IN THE UNITED STATES PATENT AND TRADEMARK OFFICE

Serial No. 10/657,025

: NUCLEAR REACTOR

PETITION UNDER 37 CFR § 1.181

FIG. 6

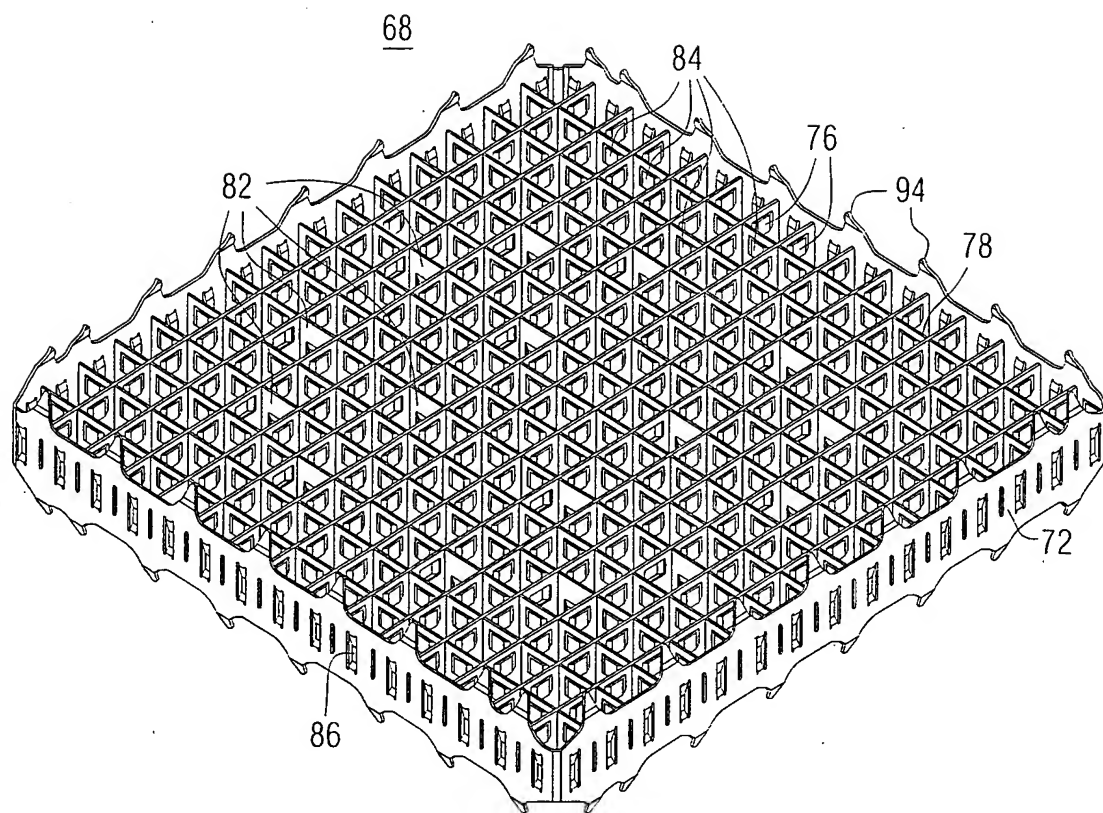
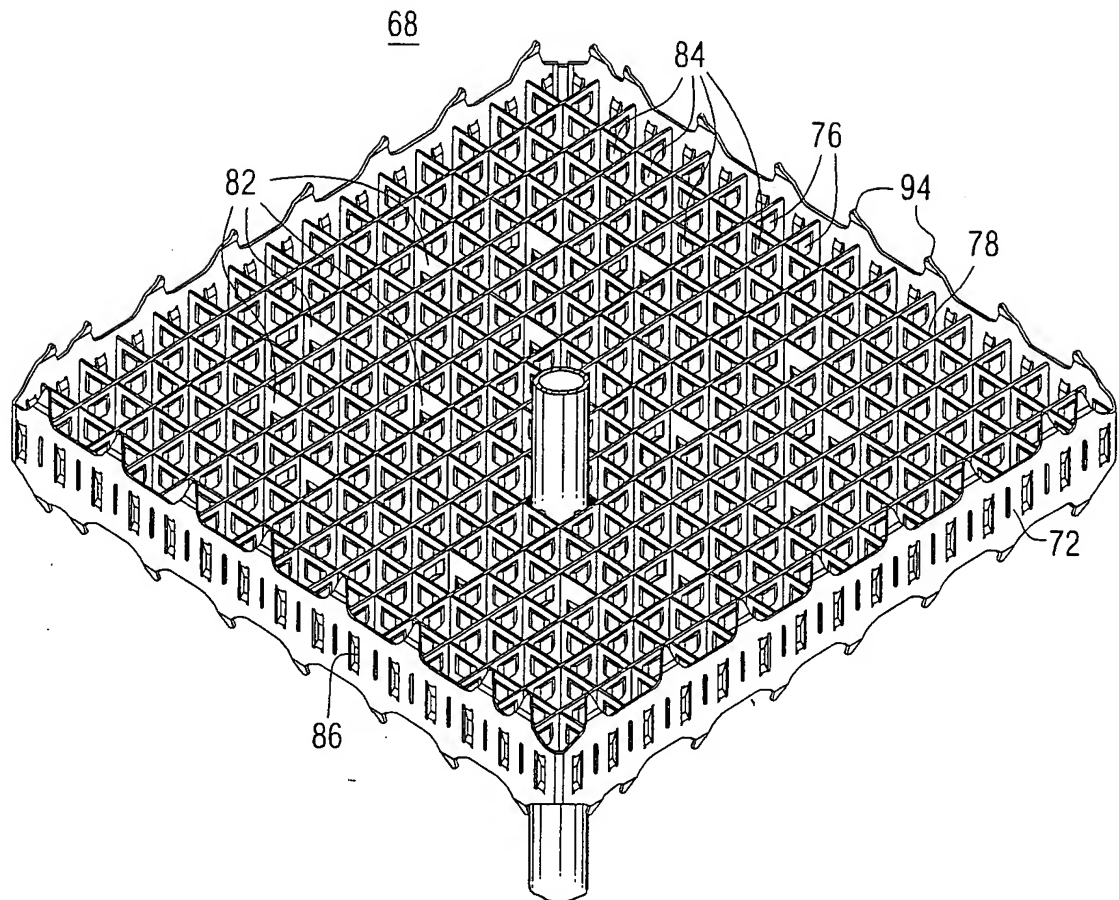
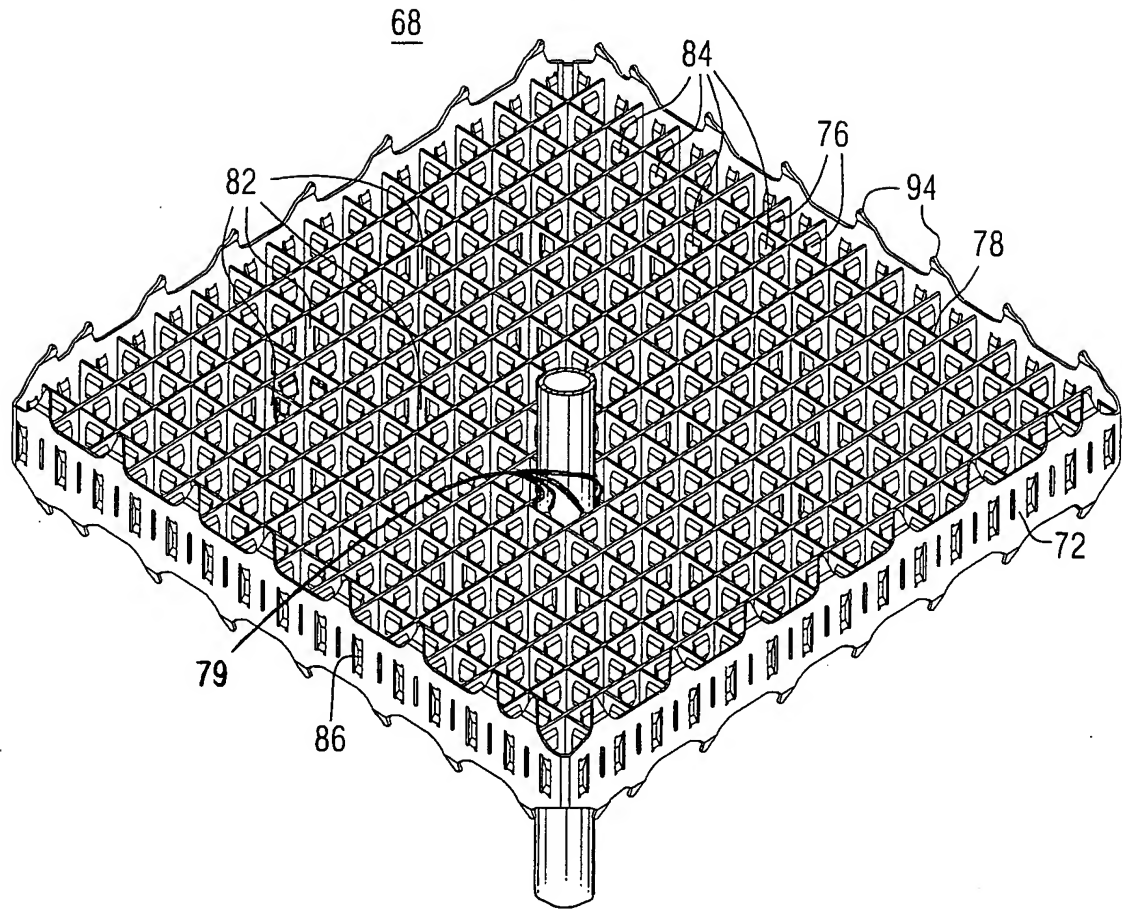
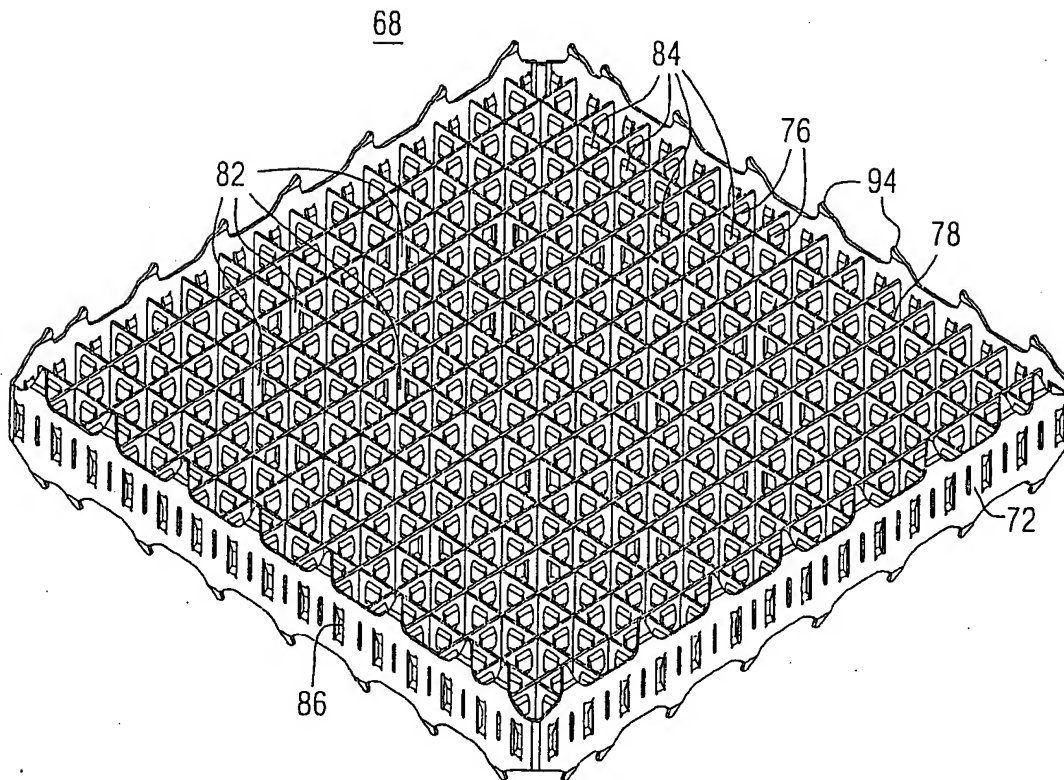
It is immaterial as to whether Fig. 6 shows the outer strap of the auxiliary grid as having vertical springs because the claimed relative difference in contact area of the dimples and/or springs, is with the inner straps of the two different grids (e.g., see the specification on page 11, lines 29+).

None of the drawing figures illustrate the actual contact areas of any of the springs and/or dimples.

Despite applicants' arguments to the contrary, it is not seen wherein Fig. 6 shows both vertical springs and dimples on the inner straps nor does it show a common plane intersecting both the vertical springs and the dimples.

Amended Fig. 6 does not clearly show a guide tube attached at the cell corners by butt-welds (it is not known what the slightly darkened portions at the two illustrated diagonal corners of the cell (through which the guide tube passes) is supposed to represent).

Additionally, it has not been shown that the term "mechanically or metallurgically affixed" inherently means a "butt-weld" and, in this art, such "butt-welds" inherently span the space between the square cell corner and the outer circumference surface of the guide tube.

The Examiner further objected to the amendment to the specification, stating that Fig. 6 shows a 15x15 array, not a 17x17 array.

Figure 6 shows vertical springs on the outer strap of the auxiliary grid, it does not show vertical springs on the inner strap. The inner strap only shows a horizontal dimple at the upper end of the cell wall.

It is immaterial as to whether Figure 6 shows the outer strap of the auxiliary grid as having vertical springs because the claimed relative difference in contact area of the dimples and/or springs, is with the inner straps of the two different grids.

Despite applicants' arguments to the contrary, it is not seen wherein Figure 6 shows both vertical springs and dimples on the inner straps, nor does it show a common plane intersecting both the vertical springs and the dimples.

Claim 9 calls for the fuel assembly of Claim 8 wherein the dimples and/or springs on the walls of the respective auxiliary grid support cells are co-planar. Referring to Figure 6, it can clearly be seen that a common plane intersects both the vertical springs and the dimples, which is not the case in the main support grid design.

Claim 13 recites that the auxiliary grid is mechanically or metallurgically affixed to at least some of the guide tubes. The amended Figure 6 clearly shows the guide tube through an auxiliary grid attached at the cell corners by butt-welds. Accordingly, amended Claim 6 should cure the Examiner’s objections to the drawings.

In a response mailed February 22, 2005, applicants amended Fig. 6 (attached hereto as Exhibit C) showing the welds attaching the control rod guide tubes to the grid cell in a more pronounced fashion and labeling them with reference character 79. Reference character 79 was also added to the corresponding description in the paragraph spanning pages 11 and 12. Fig. 6

was also amended to better show that the springs in the grid cells that have springs, i.e., fuel rod support cells are co-planar and are oriented in the vertical direction. Support for both of these changes can be found on page 11 of the specification. The specification was additionally amended to correct the reference to Figs. 4 and 6 in the paragraph beginning on page 9, line 24. It should be clear from the figures that Fig. 6 illustrates a 15x15 array and Fig. 4 shows a 17x17 array. In the Remarks/Arguments section of the response of February 22nd, applicants identified that they disagreed with the Examiner that the drawings did not show the relative size of the contact areas of the dimples and/or springs of the auxiliary support cells versus the main support cells, and that the features of Claims 9 and 13 were not shown. However, for the sake of advancing prosecution, applicants have further amended Fig. 6 to clearly show that the dimples and/or springs are on the vertical and they are all within the same plane. Applicants directed the Examiner's attention to Fig. 5, which shows the springs of the traditional grid on a diagonal with the contact area shown relative to the width of the cell as being substantially less than that shown for the vertical springs and dimples shown in Fig. 6 relative to the cell wall width illustrated in Fig. 6. In support of this proposition, applicants cited the Federal Circuit in *Hockerson-Halberstadt Inc. vs Avia Group International, Inc.* (222 F.3d 951, 956, and 55 USPQ F.2d 1487, 1491, Federal Circuit 2000) which stated: "It is well established that patent drawings do not define the precise proportions of the elements and may not be relied on to show particular sizes if the specification is completely silent on the issue". In this instance, the specification does add to the drawings by clearly stating on page 11, starting at line 6, that the dimples and/or springs are co-planar and, on line 8, that the springs are on the vertical rather than on the diagonal. Starting at line 29, the specification specifically states: "The inner straps 76 and 78 on the auxiliary grids provide for a larger contact area between the dimples/springs and the fuel elements than are provided by the corresponding contact areas on the main support grids 46". Applicants also cited the opinion of the Court of Customs and Patent Appeals stated in *In re: Chitayat*, 408 F.2d 475, 161 USPQ 224 (1969) that: "Arguments based on mere measurement of patent drawings are of little value in the absence of a description in the specification of relative dimensions. Here, we have both a clear statement in the specification and the relative dimensions of the prior art springs shown in Fig. 5 relative to the width of the cells walls as compared to those of the invention shown in Fig. 6. Applicants also cited the opinion in *In re: Wilson* 312 F.2d 449, 454, and 136 USPQ 188, 192 (CCPA 1963), which stated: "Patent drawings are not working

With regard to Claim 13, which calls for the auxiliary grids being maintained in their axial position by being mechanically and metallurgically affixed to some of the guide tubes, applicants pointed out that reference character 79 has been added to Fig. 6 to clearly show weld connections between the guide thimbles and the grid straps. Applicants further pointed out that it is well known in the art that a weld creates a metallurgical connection between the welded members and that the references cited by the Examiner evidence that it is also well known to create a mechanical connection at the joint as a means of affixing the guide thimbles or sleeves that the guide thimbles are attached to, to the cell walls. In view of the foregoing arguments and the amendments to the specification, it was respectfully requested that the objections raised in Paragraphs 1 and 2 of the Office Action be withdrawn.

Applicants are at a loss as to what the Examiner is referring to, because the amendment provided to Fig. 6 in Exhibit D, which accompanied applicants' Request for Continued Examination, clearly shows the springs and/or dimples on the inner straps in a vertical orientation, all on the same plane. 37 CFR § 1.83(a) provides:

It is respectfully asserted that applicants have complied with this requirement. In Paragraph 2 of the Office Action, the Examiner has asserted that Fig. 6 (in Exhibit D) has not been approved as it is drawn to new matter. It is respectfully asserted that the amendments to Fig. 6 were merely made to conform the drawings to the description in the specification as quoted above. Therefore, the same should not be considered new matter.
